10/14/08  
73FR 60726

## GOT WATER?

Progress Energy Florida  
**Levy Nuclear Plant  
 Units 1 and 2**  
 Part 3, Environmental Report  
 LNP REMP Sampling Locations  
 FIGURE 6.2-3  
 Rev 0

Progress Energy Florida  
**Levy Nuclear Plant  
 Units 1 and 2  
 Part 3, Environmental Report**  
 Future Site/Vicinity Recreation/Trust Lands  
**FIGURE 4 1-5** Rev 0

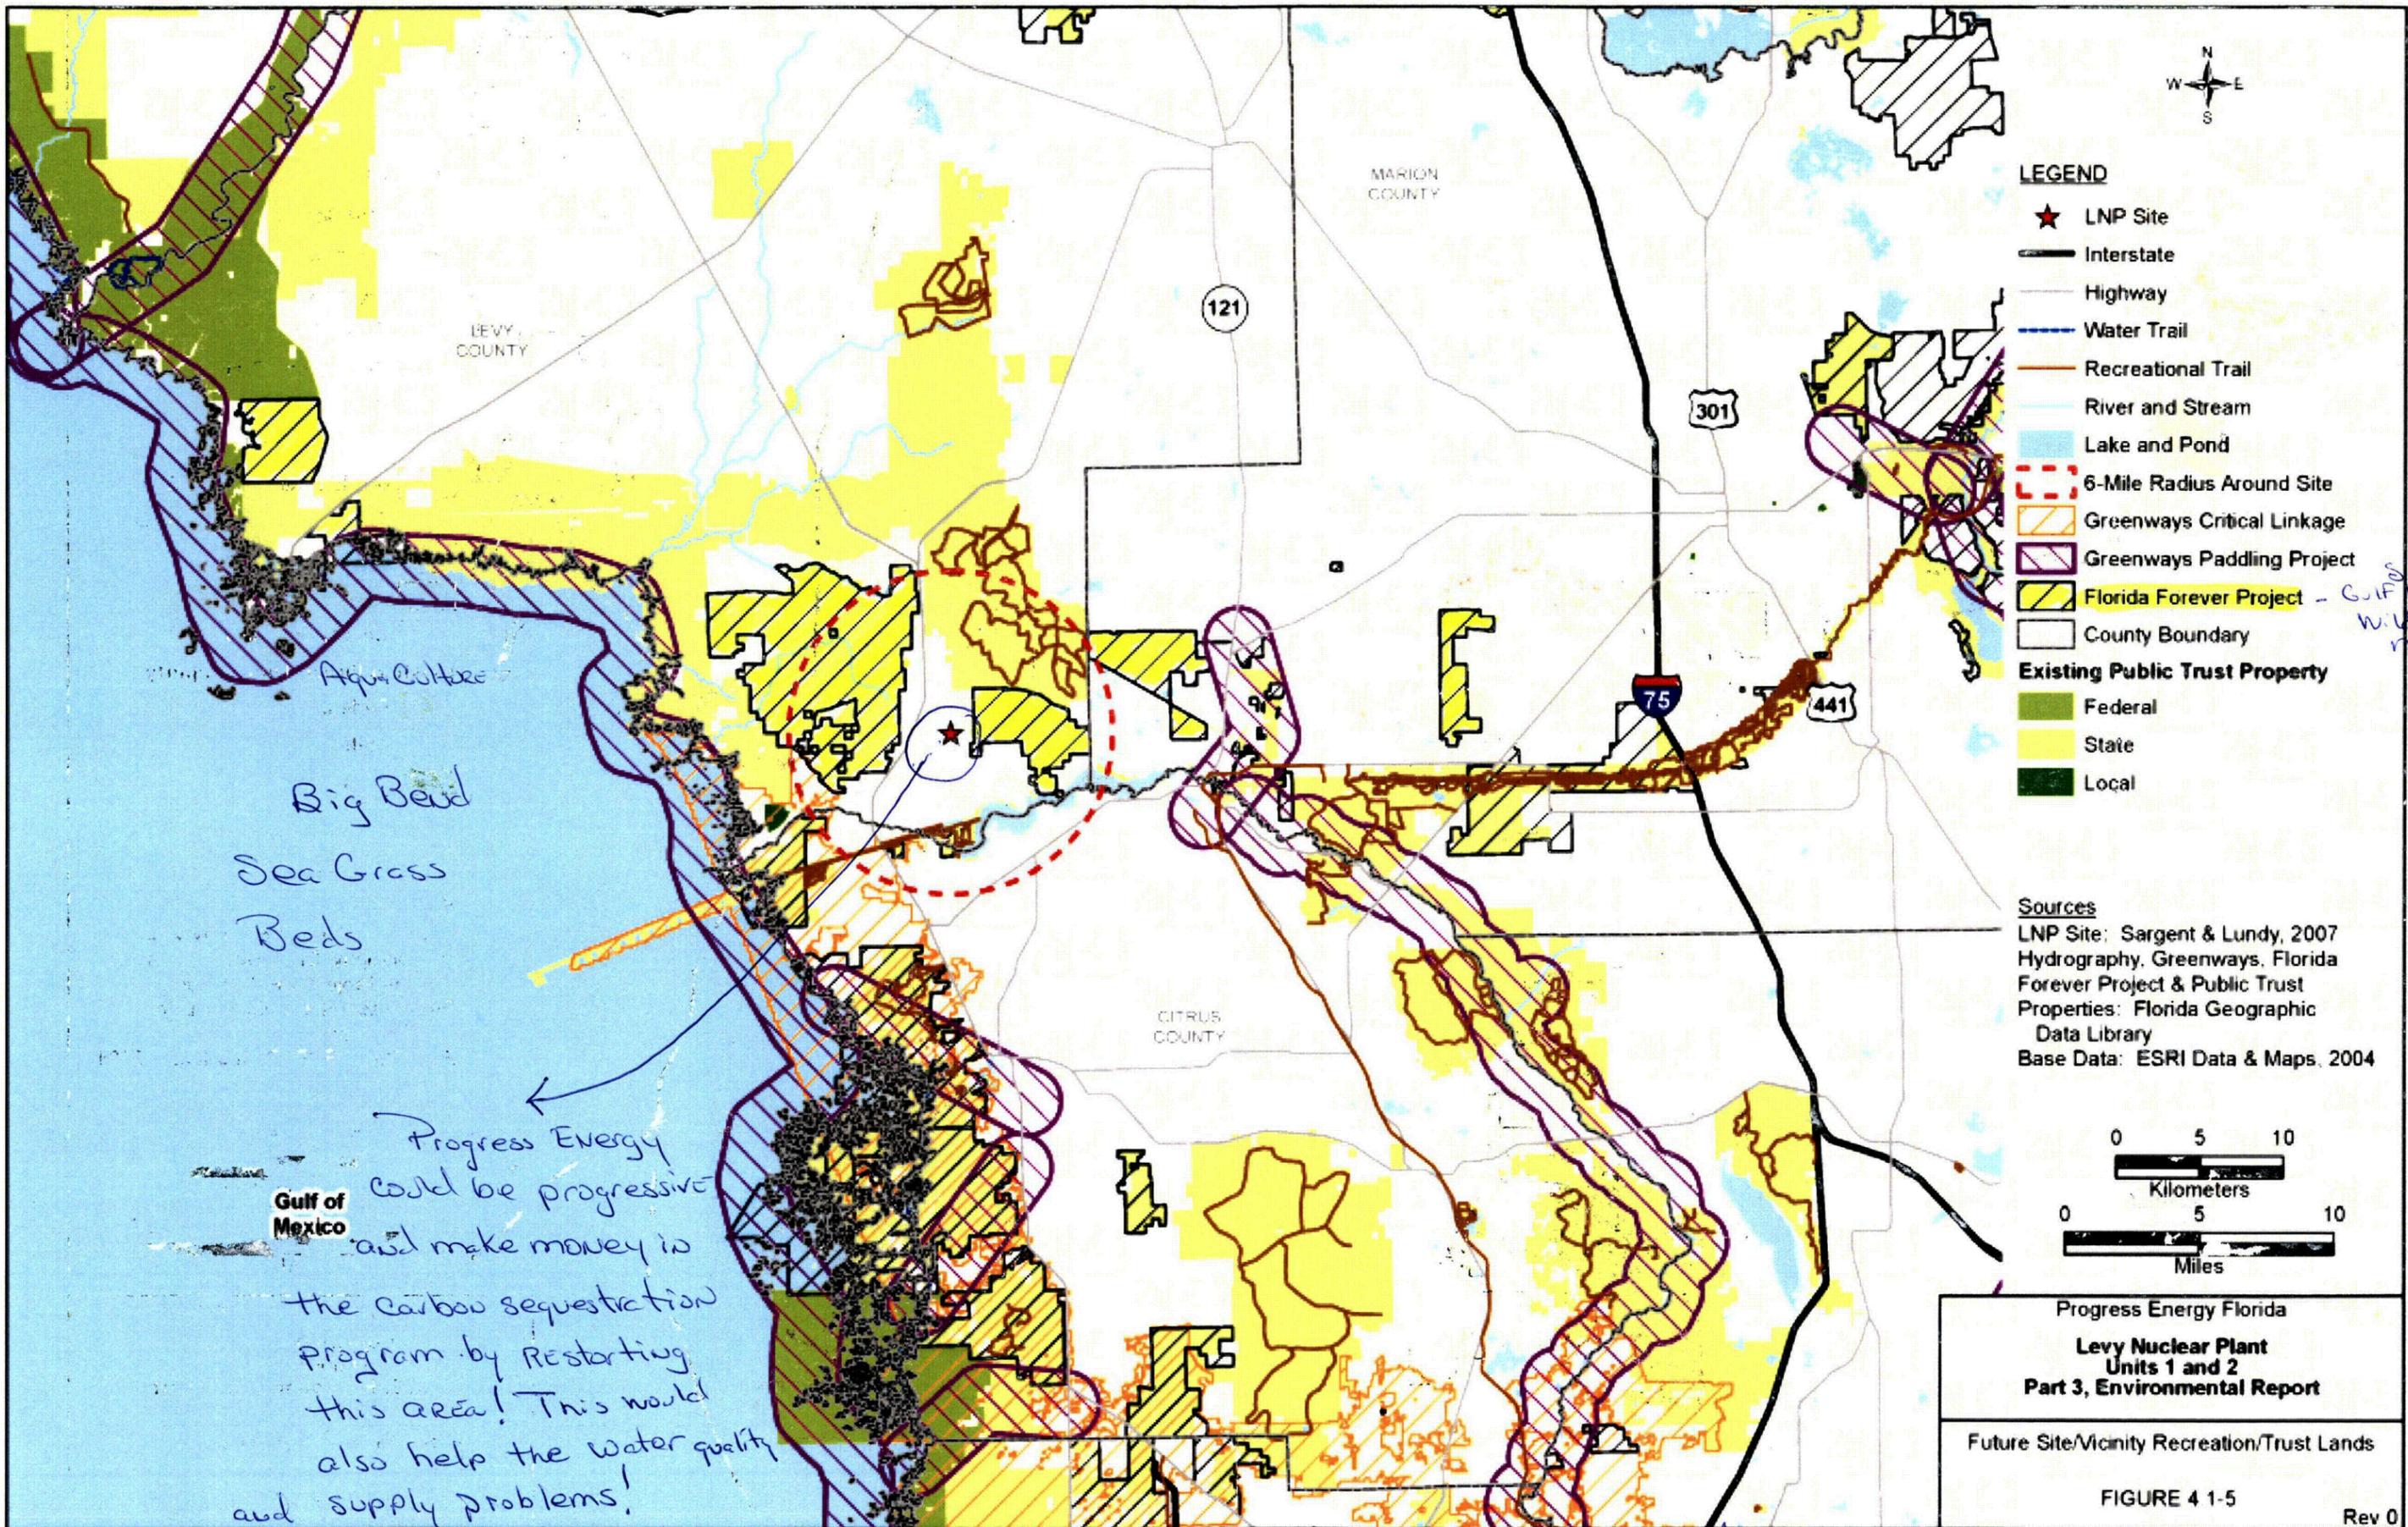
Some is  
Wildlife  
management  
AREA  
NOW

Aqua Culture  
 Big Bend  
 Sea Grass  
 Beds

Progress Energy  
 could be progressive  
 and make money in  
 the carbon sequestration  
 program by restarting  
 this area! This would  
 also help the water quality  
 and supply problems!

Lots of people depend on this area to provide food for their families! -Think about bioaccumulation over time!
